RE: Bid Package "B", Building
Creekside Elementary School
BG #04-247
PFGW Project # 0350

I am in receipt of your proposal dated June 20 relating to tile pattern changes in the six student restroom in the amount of \$1,310.00. This proposal is acceptable. Please proceed with ordering and/or installing tile per previous correspondence. I will include this item in the next change order.

We received your proposal for adding pattern elements in the six student rest room listed below. We have elected to not proceed with adding the previously detailed and priced elements. However as a second option we have via attached drawings MOD 18.1 and MOD 18.2 with a layout for consideration and discussion.

MOD. 18.1

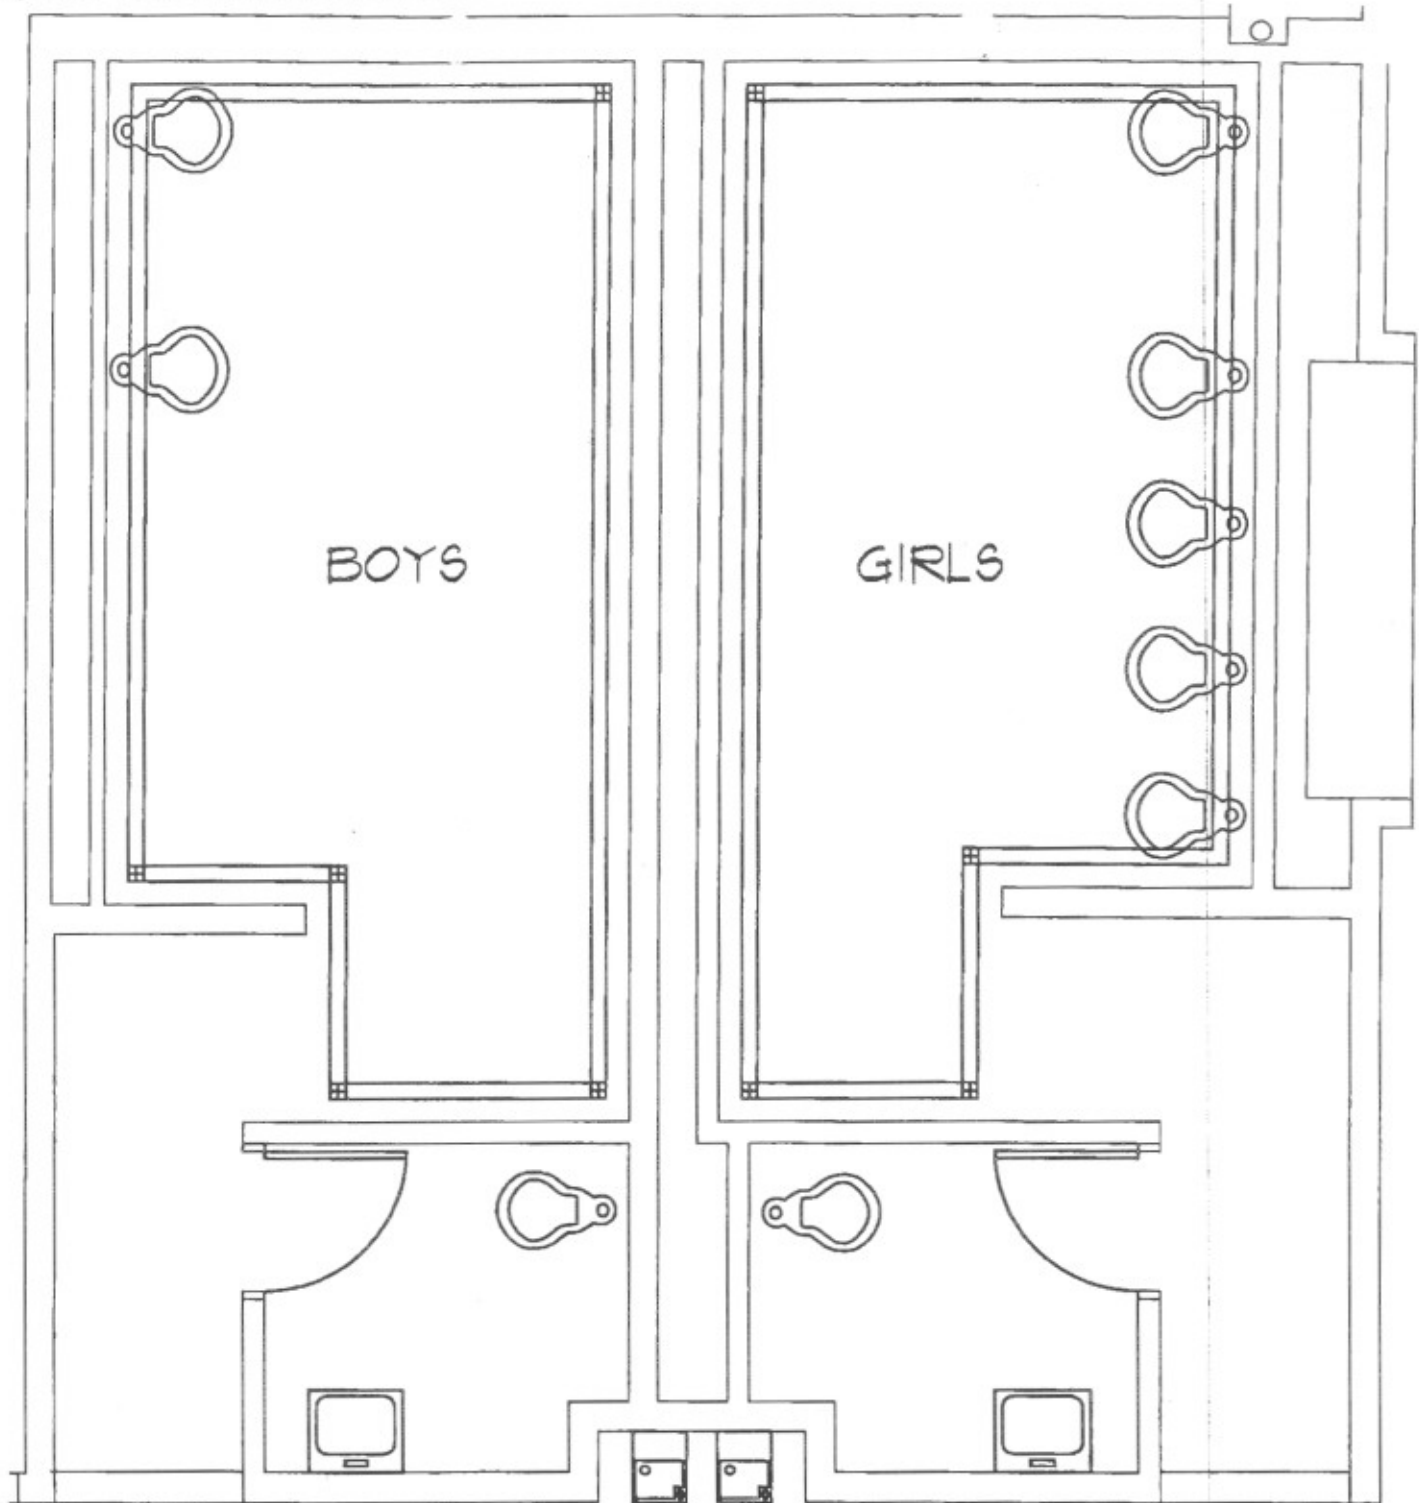
This second layout has a 4" wide stripe using **"Butterscotch D343"** 2" x 2" tiles around the room with a 4" x 4" square of **"Red D017"** (composed of 4, 2" x 2") tiles (see MOD 8.2).

MOD. 18.2

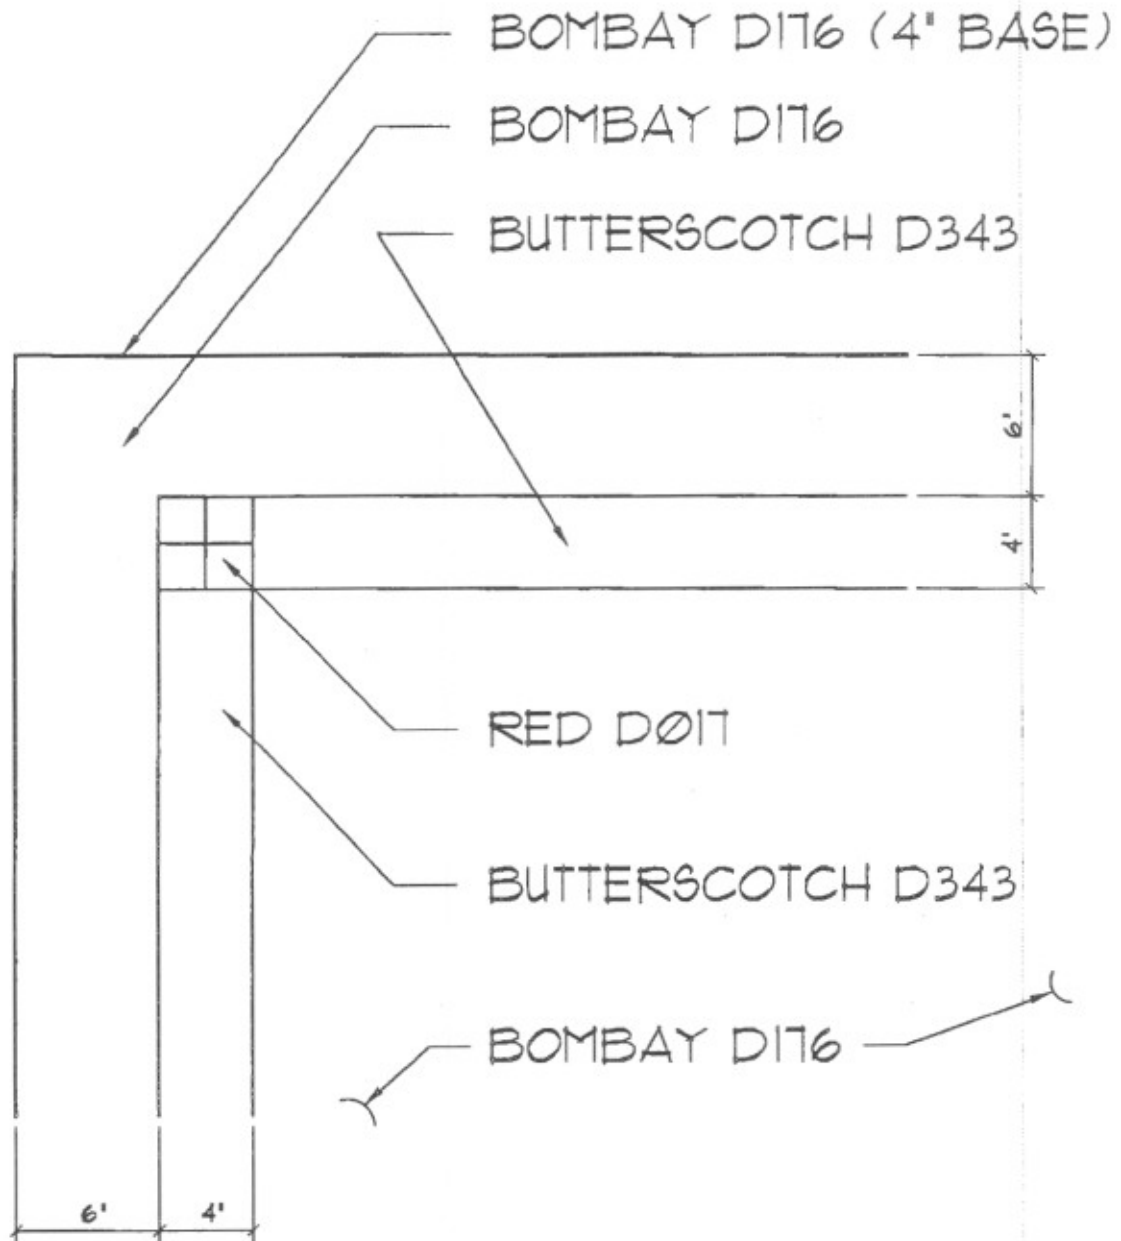
Per your request dated June 13, 2005, to add pattern elements in the six student restrooms per MOD18.2 drawing please add \$1,310.00.
